ARCADIS GUIDANCE TO THE CIVIL AVIATION  
AUTHORITY ON HEATHROW EXPANSION PROGRAMME

# HIGH-LEVEL ASSESSMENT OF THE ARORA SCHEME PROPOSAL

### Report No.

January 2019

Figure 4: Project Risk Process Map

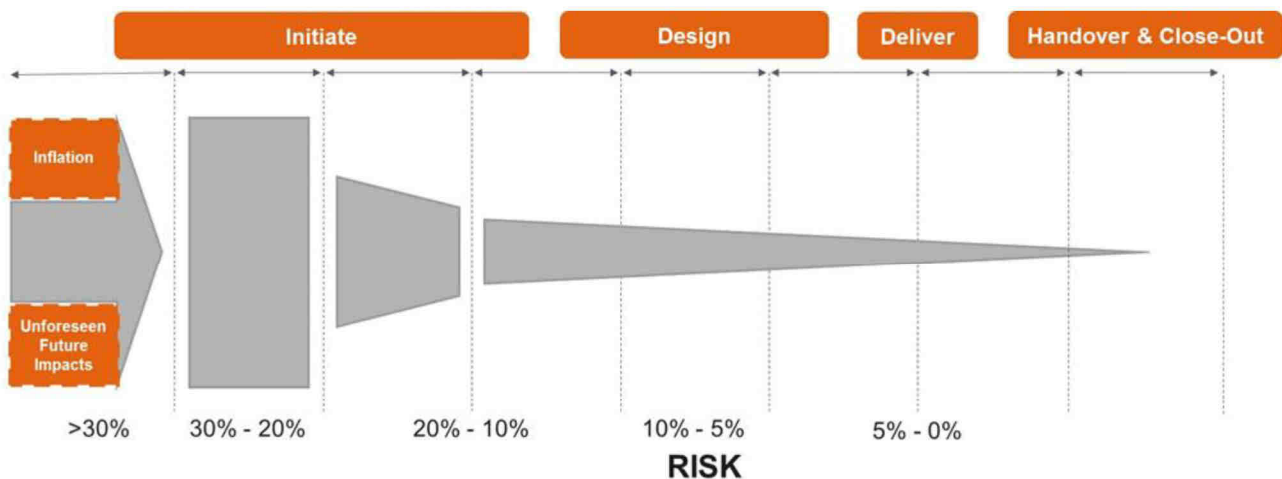
Currently, Arcadis are not aware of any Arora risk management structure in place and Arora has applied risk at [REDACTED].

Given the current level of maturity of the Arora Scheme Proposal, together with the inclusion of [REDACTED] ([REDACTED]) of costs coming from the Airport Commission, Arcadis believe that the level should be more in line with the Process Map in Figure 4 and, as a minimum risk, should be at 30%.
